NEDO-33922-A
Revision 3
June 2022

BWRX-300 Containment Evaluation Method

ONTARIO POWER GENERATION	
OPG Document Number	
NK054-REP-03555-00001	
OPG Security Classification	
Confidential	
ACCEPTED	
ACCEPTED AS NOTED	x
REVISE AND RESUBMIT	
	March 14, 2024
Signature	Date
Name: Balraj Jassar, Manager	
Dept: Nuclear Safety, Projects, DNNP	
This acceptance does not relieve the contractor from responsibility for errors or omissions or from any obligations or liability under this contract.	
Notes: Refer to the adjacent notes

SUBJECT: FINAL SAFETY EVALUATION FOR GE-HITACHI LICENSING TOPICAL REPORT NEDC-33922P, REVISION 2, "BWRX-300 CONTAINMENT EVALUATION METHOD" (DOCKET NO. 99900003)

Figure 5-2: TRACG RPV Nodalization

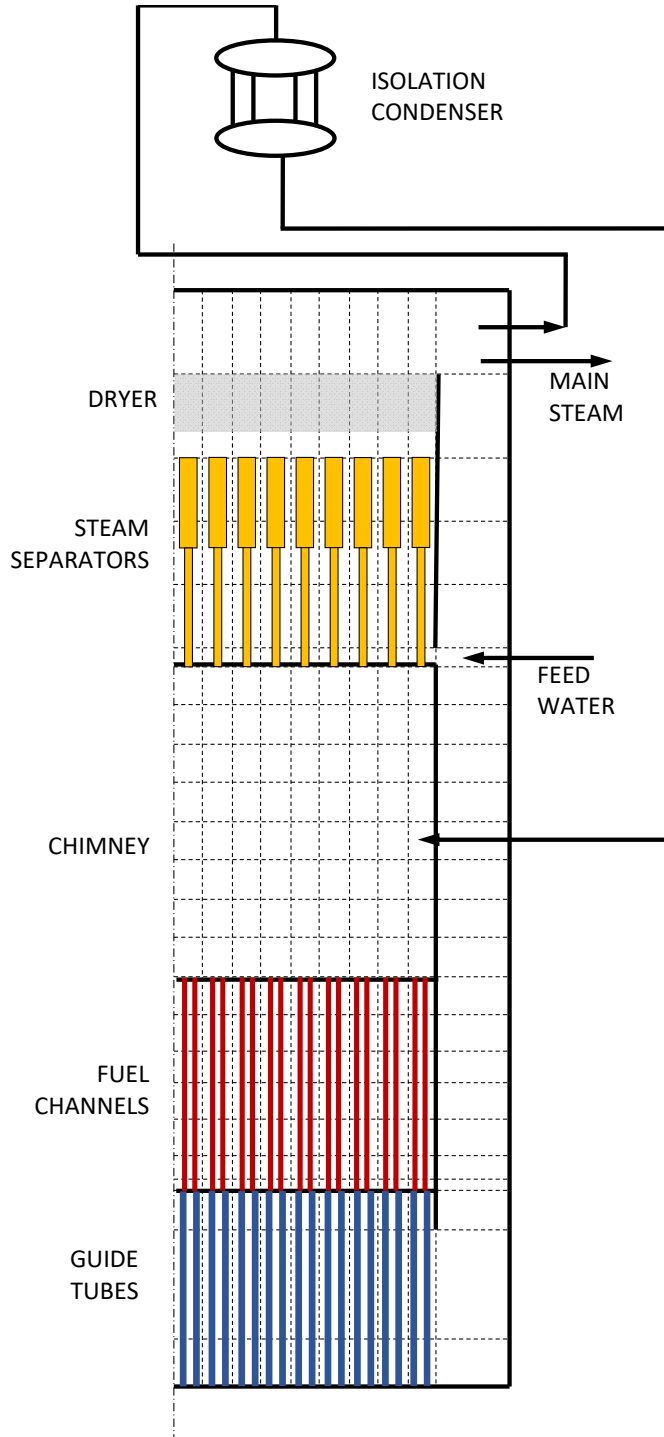
Main feedwater pumps, isolation valves and specific piping segments are used to model inlet piping at the elevation near the top of the chimney as shown in LTR Figure 5-2. [[
